APPENDIX 4:
Proposed location of speed humps in Oldhurst Road and High Street, Pidley

PR0639 – Notice to Install Speed Cushions – High St & Oldhurst Rd, Pidley cum Fenton		
No	Objection	Officer's Comments
1	I feel that the plan to install speed cushions in Pidley will fail to achieve the desired result. From previous experience, living in a village where speed cushions were installed outside my home, speeding motorists ignored and straddled them or drove over them causing their headlights to momentarily flash up into our bedroom window.	Speed cushions offer alternative form of vertical deflection in order to control drivers' speeds where speeds are excessive. The proposed speed cushion (s) along High street and Oldhurst Rd have been positioned following design practices and are aiming at changing drivers attitudes and ensure they adhere to the speed limit of the road in question.
	I feel that a tight chicane would not only deter speeding motorists but also heavy lorries on High Street, including a weight limit would be good to tackle this issue.	Provision of chicane or buildout along Oldhurst Rd is limited by the presence of private accesses being in close proximity, in turn, it w

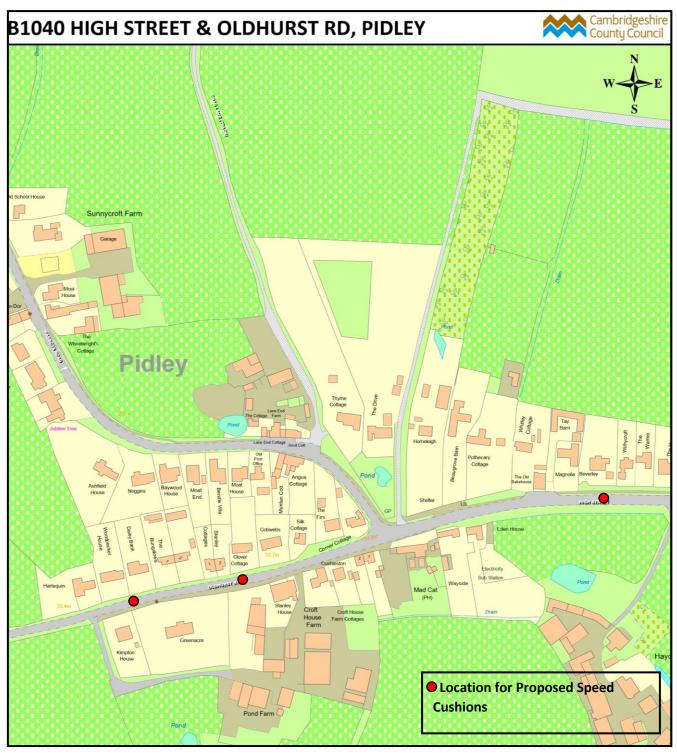
At the point where the speed cushions are proposed in the consultation, there are no kerbs so as in other locations, if cushions are deployed, non-compliant drivers can avoid them by mounting the verge which on the eastbound carriageway is adjacent to the pavement and the westbound is adjacent to an obscured deep ditch. Such measures would make the High Street less safe and it would therefore seem to be commonsense to follow Police Guidelines and not install speed cushions.

Slowing errant drivers down adjacent to Beverley does nothing to address the problem of children crossing the High Street to the bus stop, or residents crossing the High Street to the dwellings or Public House at the end of the High Street.

I wish to object to the proposed as they are not necessary given the existing measures in place, with the possible exception of Oldhurst Road (1 set only).

Speed cushions cause damages to cars overtime, and the proposal would mean that the whole village is locked in by speed cushions, meaning villagers cars will suffer every time they leave and enter the village.

Lastly, additional bollards will be introduced within the vicinity to discourage vehicles being driven over the verge.

The speed cushions have been designed following design guidance LTN 1/07, that is, 75 mm high with on/off ramp gradients of about 1:15. Vehicles travelling over the speed

cushions at appropriate speeds should not suffer any damage.

Series of speed cushions (2 sets) has been proposed along the Oldhurst Road to ensure drivers travel at an appropriate speed across the full stretch. One set of cushions would be ineffective and will lead to drivers accelerating past the cushion
